VIRGINIA ELECTRIC AND POWER COMPANY
RICHMOND, VIRGINIA 23261

VIRGINIA ELECTRIC AND POWER COMPANY
SURRY POWER STATION UNITS 1 AND 2
PROPOSED LICENSE AMENDMENT REQUEST
CLARIFICATION OF REACTOR COOLANT SYSTEM
HEATUP AND COOLDOWN LIMITATIONS TECHNICAL SPECIFICATION FIGURES

MARKED-UP TECHNICAL SPECIFICATIONS AND BASES PAGES

Figure 3.1-1 : Surry Units 1 and 2 Reactor Coolant System Heatup Limitations (Heatup Rates up to 60°F/hr) Applicable for 48 EFPY

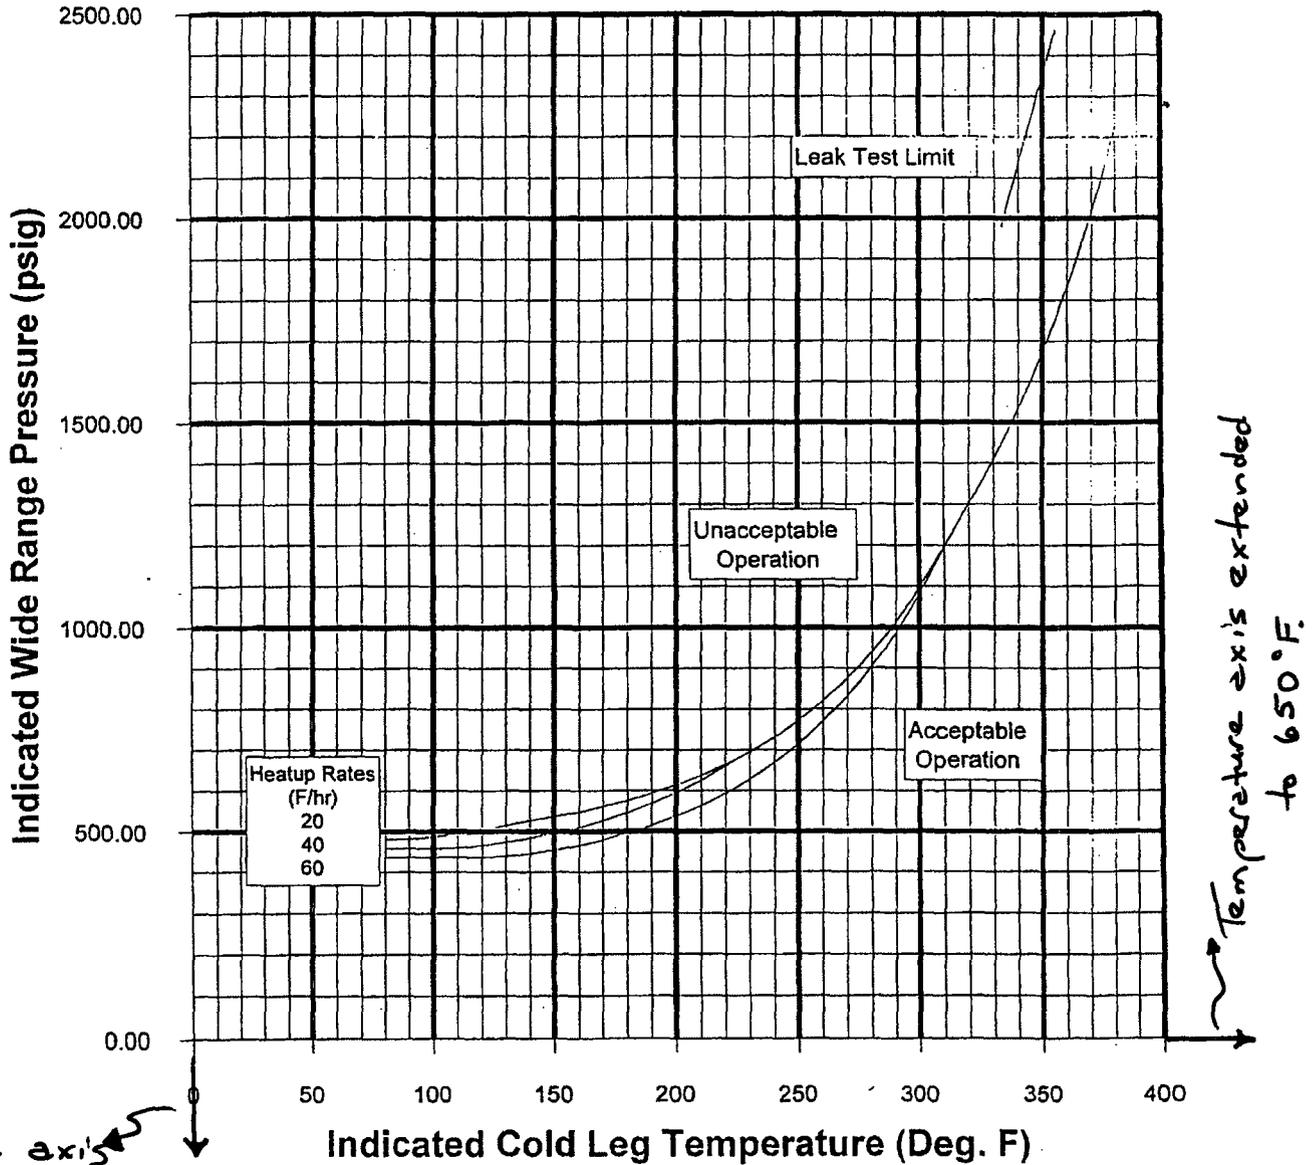
- TS Figures 3.1-1 and 3.1-2 are revised for clarification as follows:
 - The temperature axes are extended from 400°F to 650°F, which corresponds to the reactor vessel design temperature and bounds temperatures up to RCS full power operation.

- The pressure axes are extended from 0 psig to -14.70 psig to bound RCS conditions to support vacuum-assist fill of the RCS loops, which is a loop fill option addressed in the Surry RCS fill operating procedures.

- The phrase, "Limiting Boltup Temperature Surry Unit 1 Initial RT_{NDT} Closure Flange Region: 10°F," is added, since the figures do not currently address boltup temperature.

INSERT D →

Pressure axis extended to -14.70 psig

INSERT D ON FIGURES 3.1-1 AND 3.1-2:

Limiting Boltup Temperature Surry Unit 1 Initial RT_{NDT} Closure Flange Region: 10°F

- 14.70 psig Figure 3.1-2: Surry Units 1 and 2 Reactor Coolant System Cooldown Limitations (Cooldown Rates up to 100°F/hr) Applicable for 48 EFPY

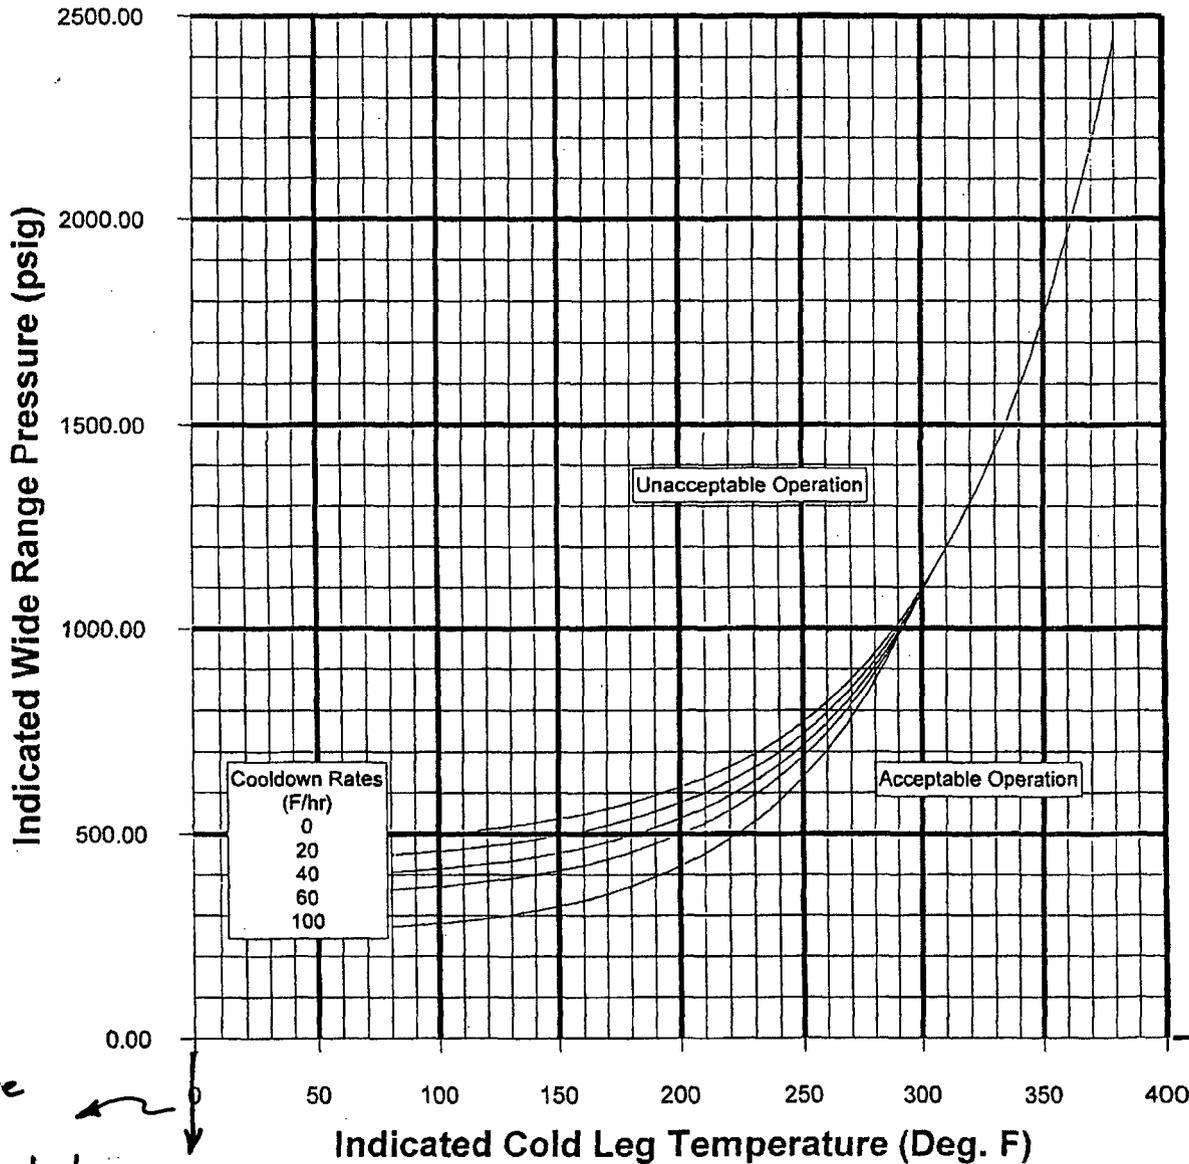
INSERT D →

Pressure axis extended to

Temperature axis extended to 650°F
